## TIMBER FRAME INSPECTION

**1234 MAIN STREET  
SYDNEY**

02/05/2023

### 1.2.1 Vapour barrier

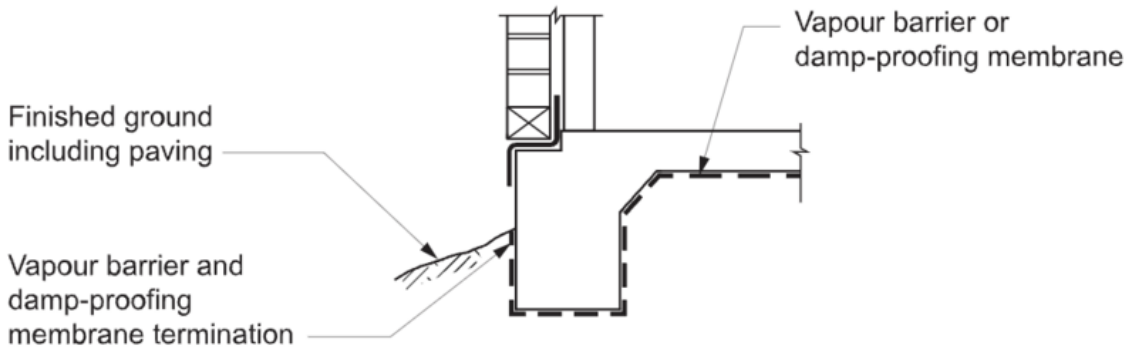
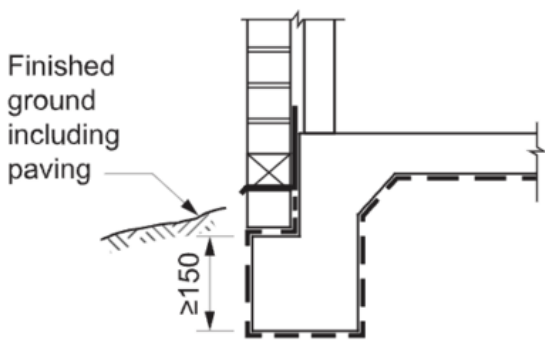
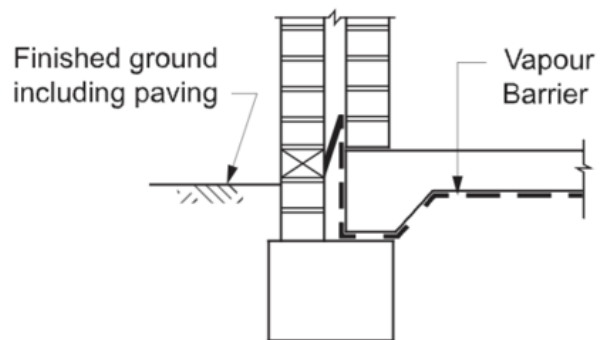
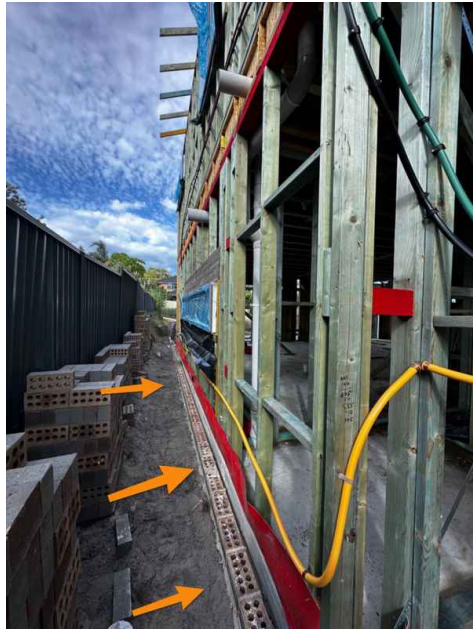
All of the existing loose fill that has been placed up against the slabs edge beams will need to be removed and the polyethylene vapour barrier properly extended up the external side faces of the edge beams to at least the height of future finished ground level or paving i.e. 75mm below the damp-proof course and bottoms of the weepholes, after which any termite barriers that are in place, if required, will also need to be properly instated.

#### FRAME EXCEEDS MINIMUM BEARING ON SLAB

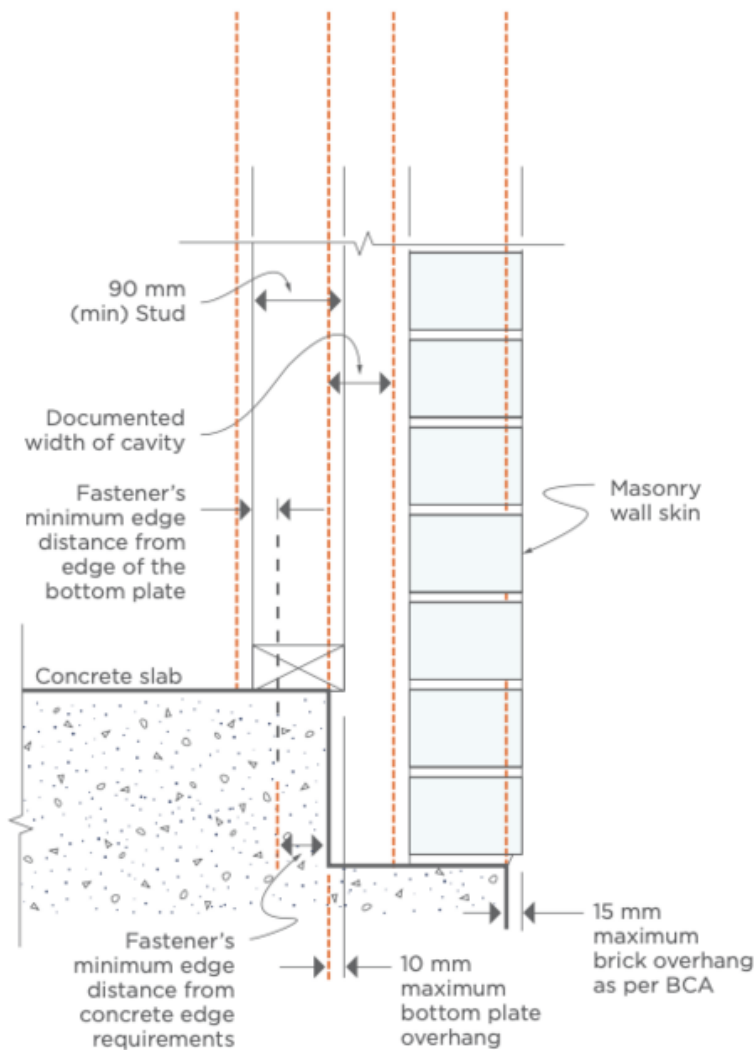
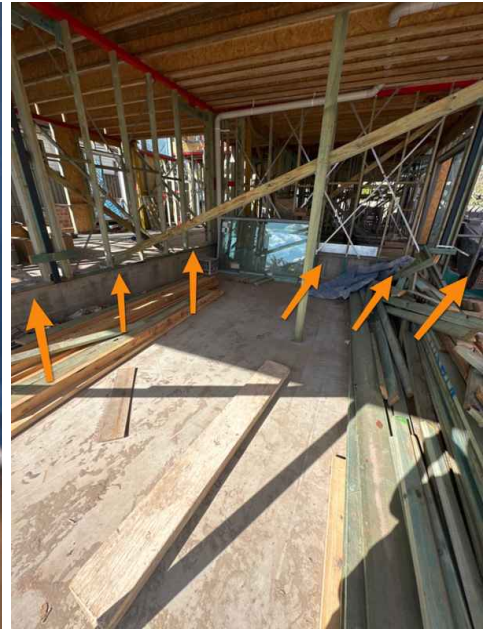
The maximum allowed overhang of a 90mm bottom plate is 10mm. The works below are non compliant.

This overhanging bottom plate will need to be supported by an appropriately designed and certified engineered system so that it complies with As 1684.2, clause 6.3.3, and the BCA.

25mm Frame overhang

60mm Frame overhang

### **NOGGINGS ARE NON-COMPLIANT**

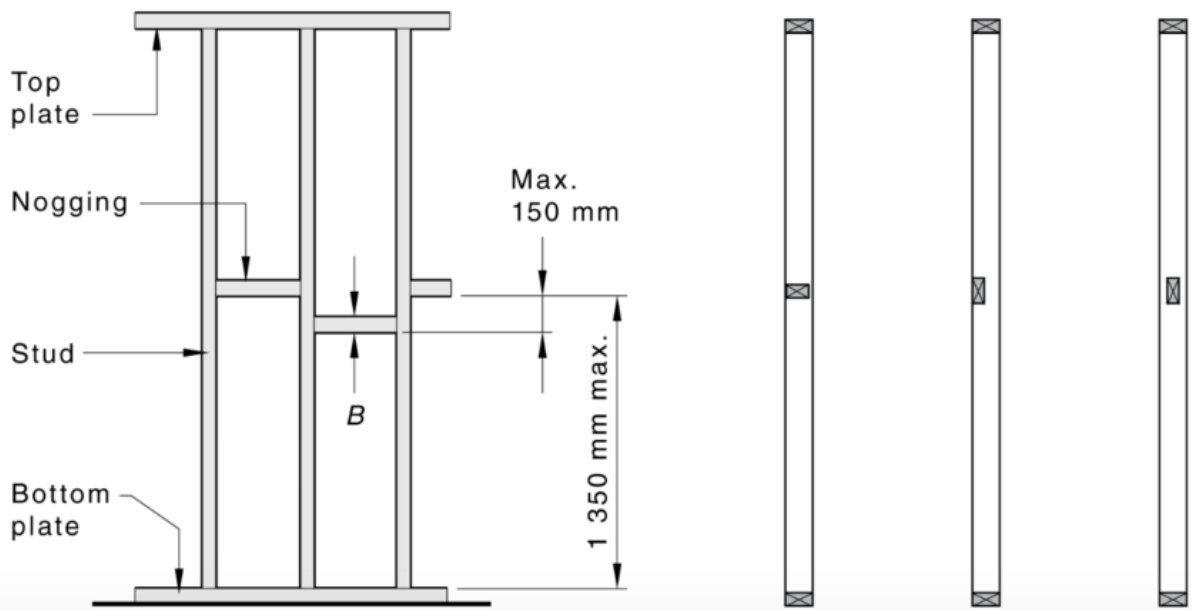
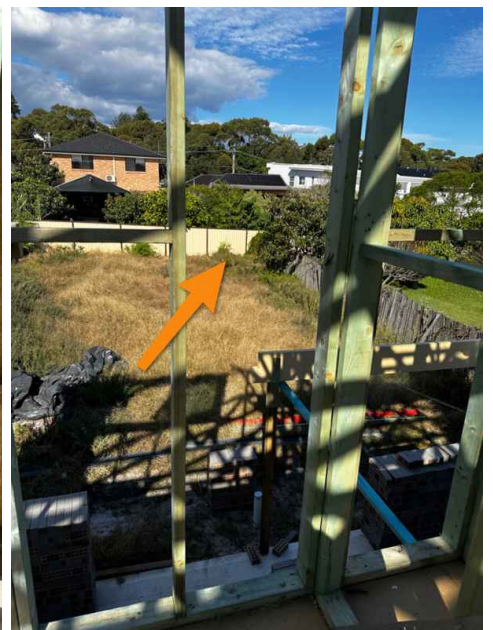
Noggings are non-compliant due to reasons below

Missing

Missing

**PLAN SPECIFIES LVL**

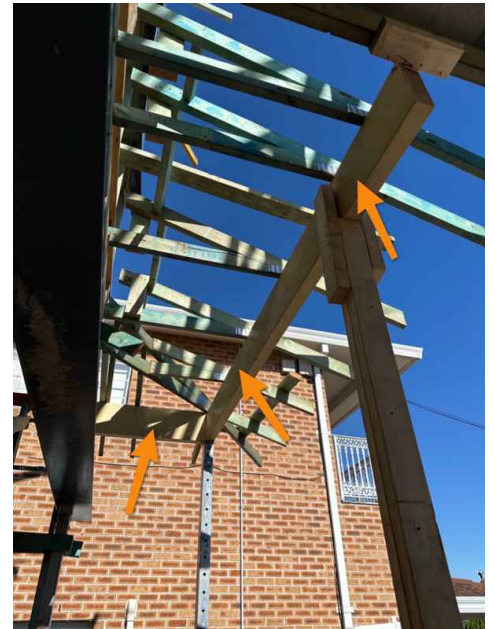
The plan specifies an LVL to be installed. Instead a primed pine beam has been installed. This does not follow the engineering documentation. It is recommended that an engineer check.

Primed pine beams installed instead of the required LVL's

**FRAMING INCOMPLETE**

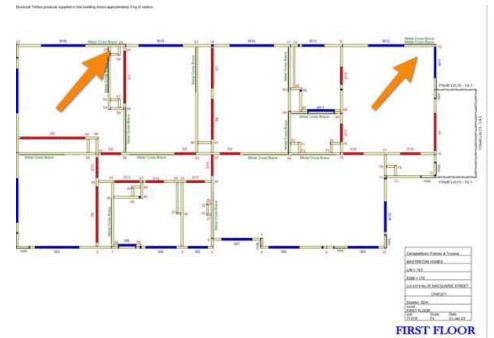
Sections of framing are incomplete

**METAL BRACING NOT INSTALLED**

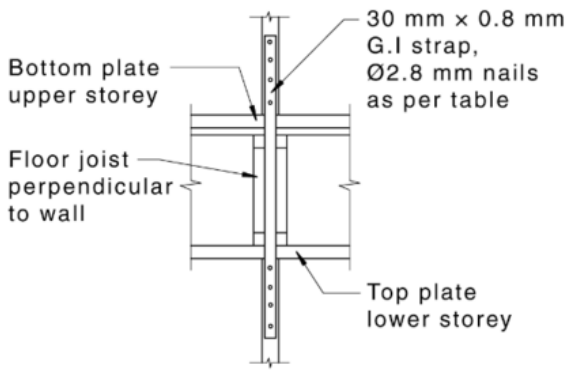
Metal bracing has not been installed in sections

Arrows show areas where bracing has not been installed

**TIE DOWN CONNECTIONS**

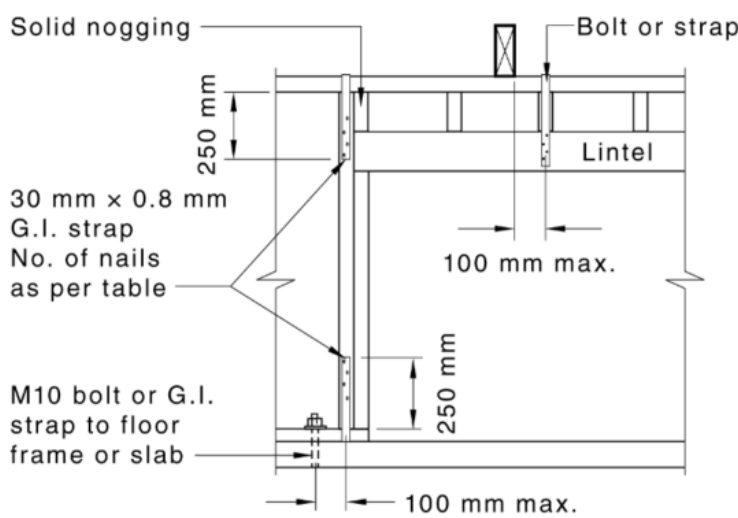
Tie down connections have not been installed to timbers where the load is transferred to the below timbers. Continuity of tie down shall be provided from the roof sheeting to the foundations. This is a requirement set out in AS1684.2:2022. Below tables show examples of tie downs.

#### INADEQUATE ANCHORS

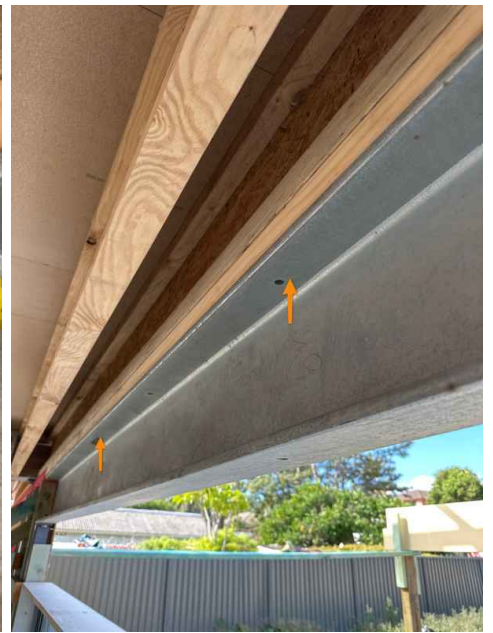
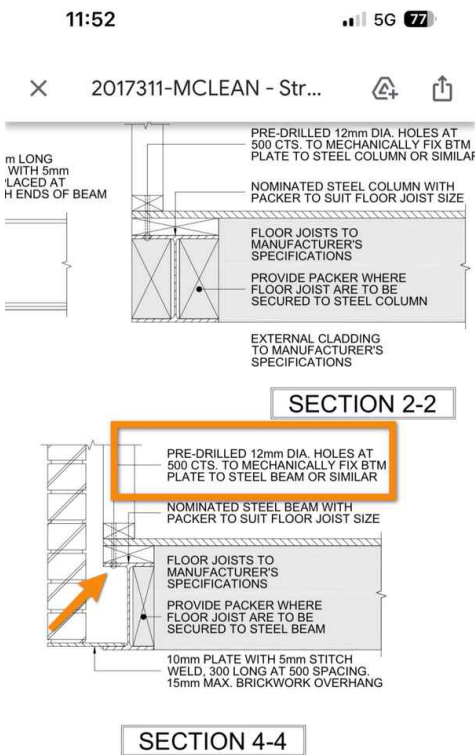
Inadequate anchors between bottom plate and steel beam as required by the engineers plans. It is required to be Mechanically fixed at 500mm centres. Currently the bugles have been installed at 600mm centres with some not finished. This is common throughout the build. It is recommended these sections be bolted as the bugle may not reach the bottom plate.

#### **INADEQUATE NAILS IN HANGERS**

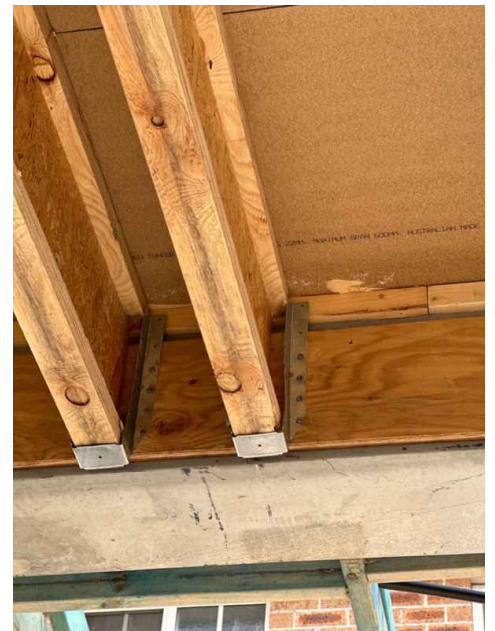
Only 4 nails were installed on each side of the hanger. As per the manufactures guide, 6 nails should be installed on either side. Please see screenshot of the manufactures guide below.

#### TRUSSES CUT

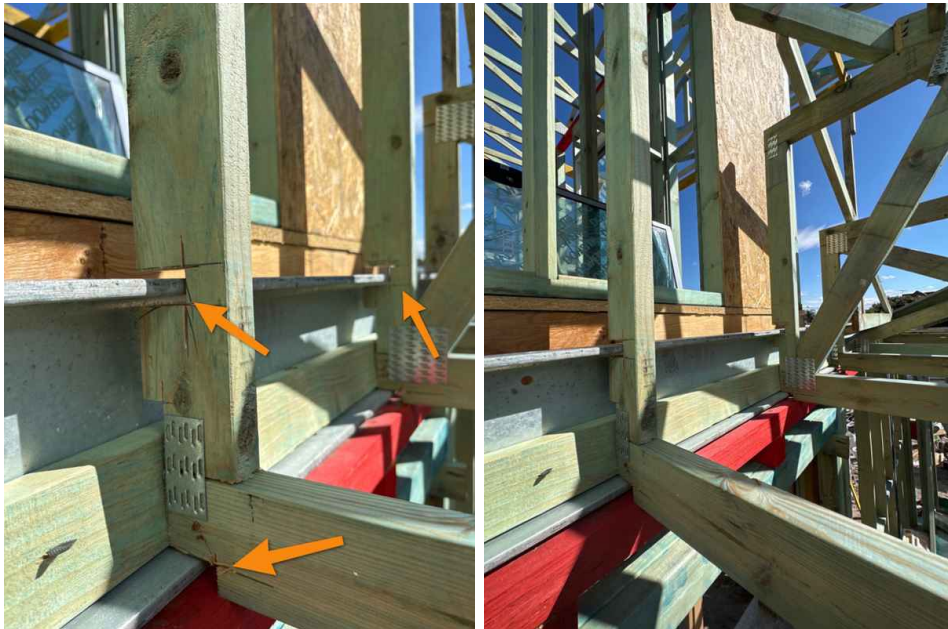
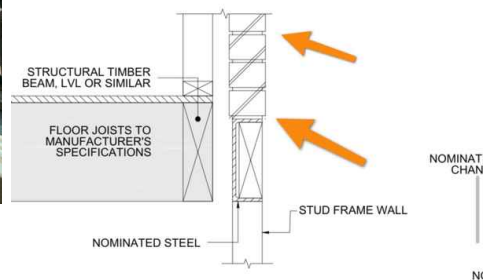
Trusses have been notched out around a steel beam. Trusses should not be altered or notched out once on site. These trusses also appear to be installed in an incorrect position as they should not be cut around the beam. This beam is installed to provide support for the brick veneer wall. With the trusses in the way there is not enough room for bricks to be installed.

#### FRAMING INCOMPLETE

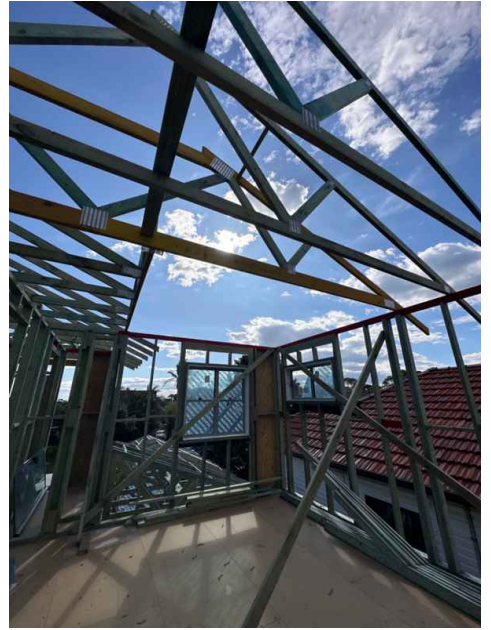
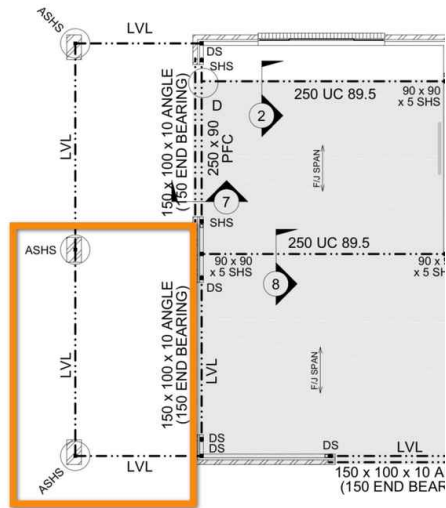
Some sections of framing are yet to be completed. It is recommended this be re-inspected once completed

### ROOF BRACING TIE OFF

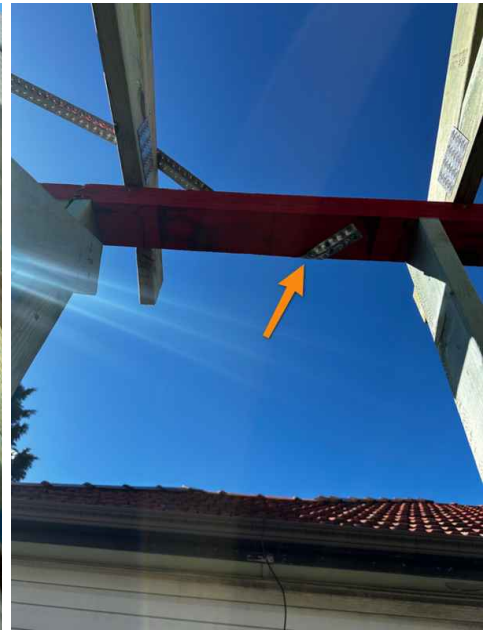
The roof bracing should terminate to the underside of the top plate

Loose nails

Terminates to the ply bracing

Example of how it should be done

### **INADEQUATE BEARING**

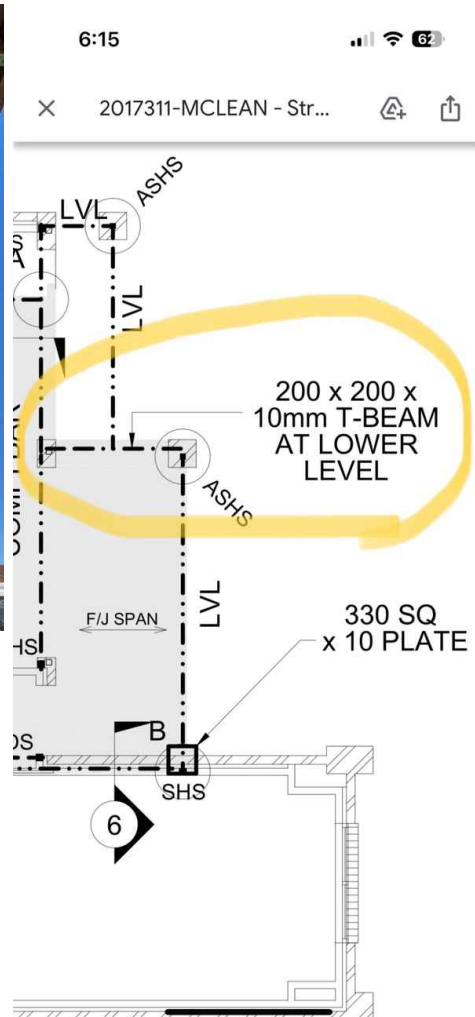
Steel posts has inadequate bearing. The steel plates have excessive overhangs to the concrete slab. These area required to have full bearing on the slab. This should be assessed by the structural engineer to determine a solution.

70mm overhang

45mm overhang from concrete slab with no fixings into the concrete slab

20mm overhang with only a single fixing

Structural load not designed to bear on timber, this has been done as it appears the slab edge was poured short

**NO BOLTS INSTALLED**

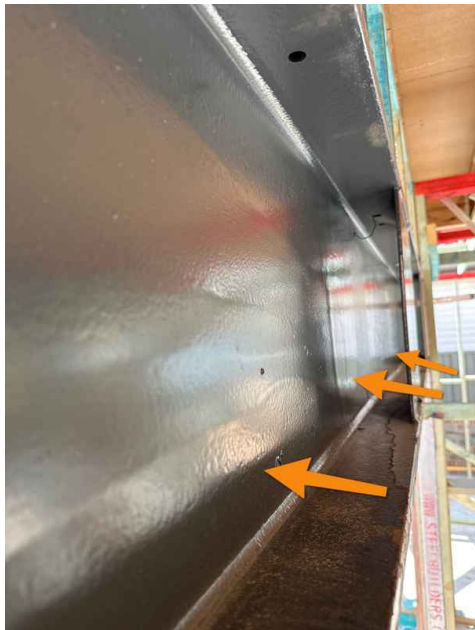
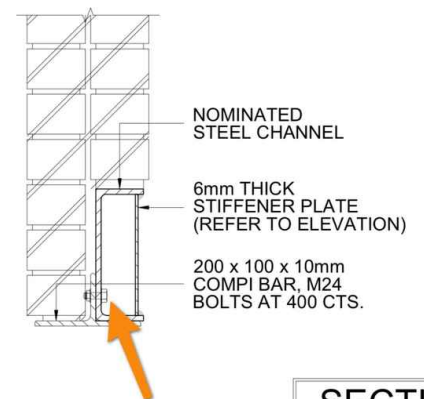
The engineers documents specify M24 bolts at 400 centres. These have not been installed.

**INCORRECT PLATE**

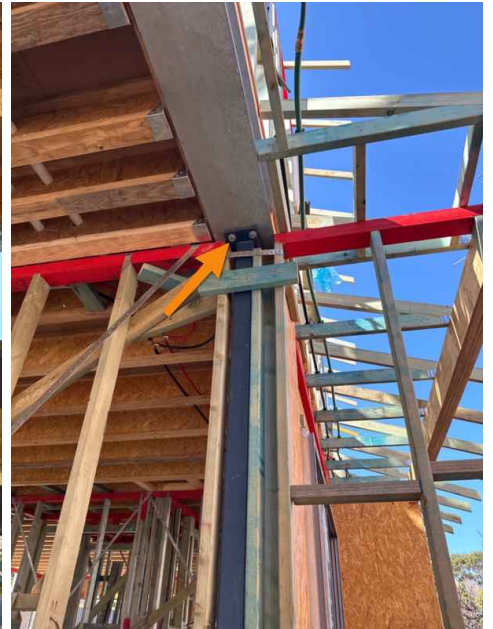
The engineer plans specify a 200mm long 10mm thick plate. What has been installed is inadequate

Plate is only 150mm

**INCORRECT BEAM**

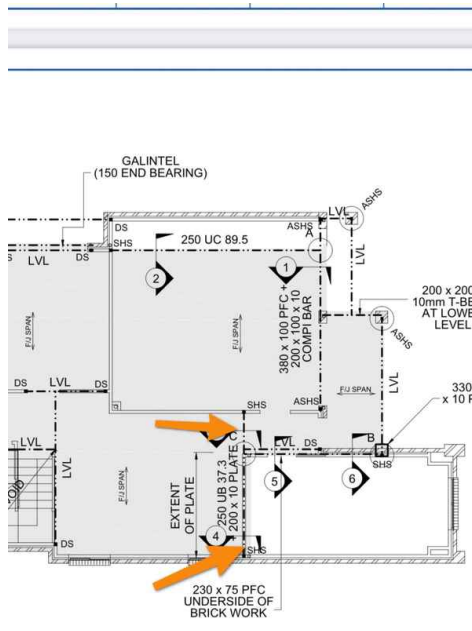
The engineers plans show a 250UBx200x10 installed. What has been installed is a 250UBx150x10

**INCORRECT CONNECTION**

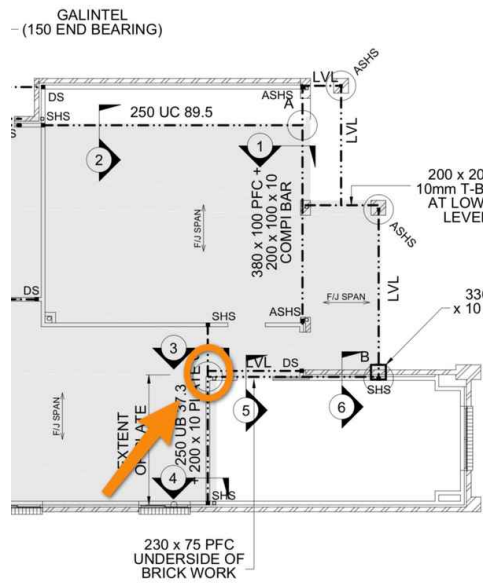
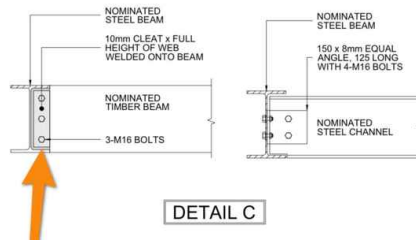
The connection between the steel beam and the timber does not match the engineers plans. The plate should be the full height of the steel beam web and and 3xM16 bolts installed as per the drawings

**INCORRECT CONNECTION 2**

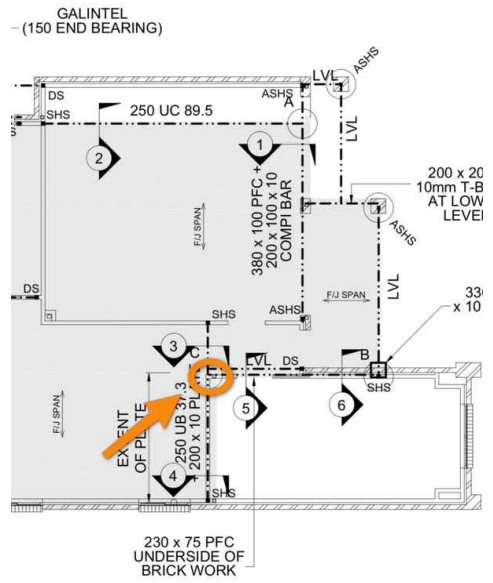
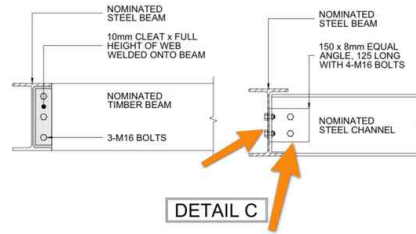
The connection between 2 steel beams doesn't not follow the engineers documentation. Currently there is only a single plate 100mm long. It is required that a 125mm EQUAL ANGLE be installed as per drawings.

**WELDING**

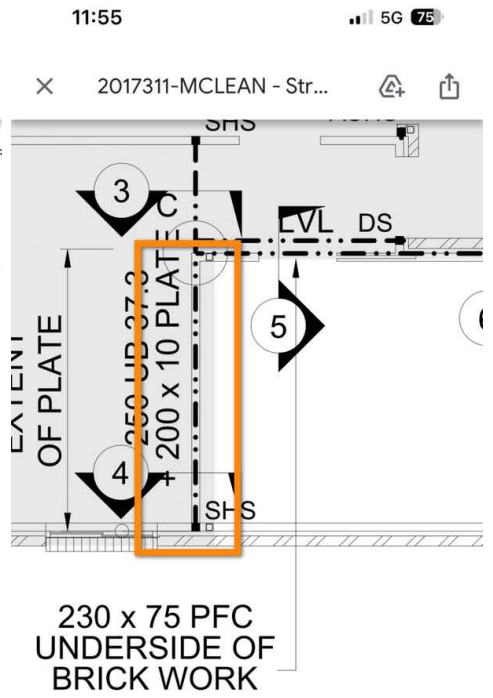
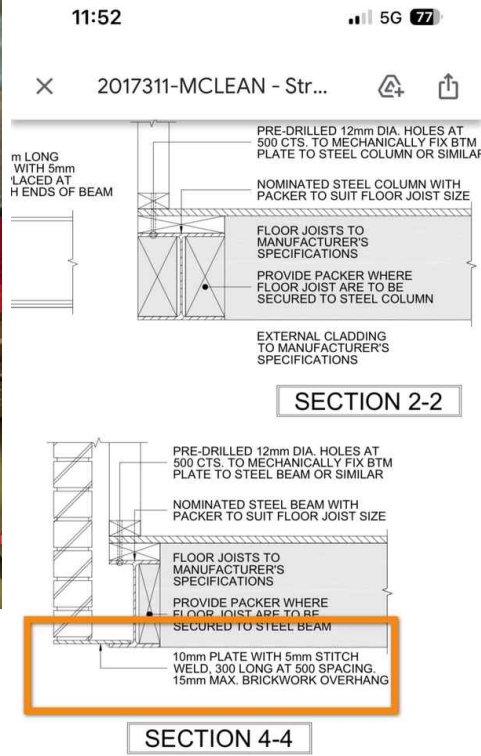
Welding does not following the engineers plans. Plans show welds should be 300mm long at 500mm spacing

**BEAM INADEQUATE BEARING**

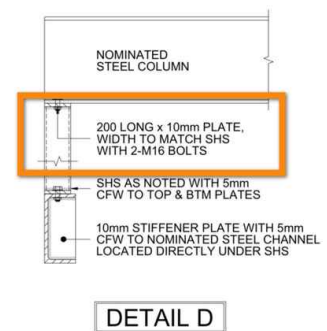
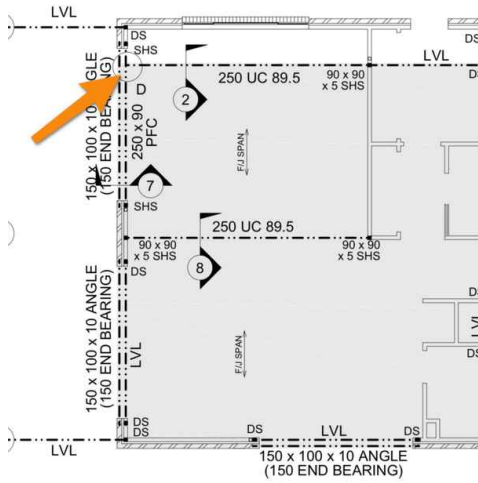
Steel beams has inadequate bearing according to the engineers plans. The engineer needs to assess these areas and provide updated documentation and solutions before proceeding.

Post plate has been cut short and now only allows a single bolt

Beam should have 200mm of bearing. Currently the last packer is only 100mm wide. This connection is not as it specified by the engineers drawings
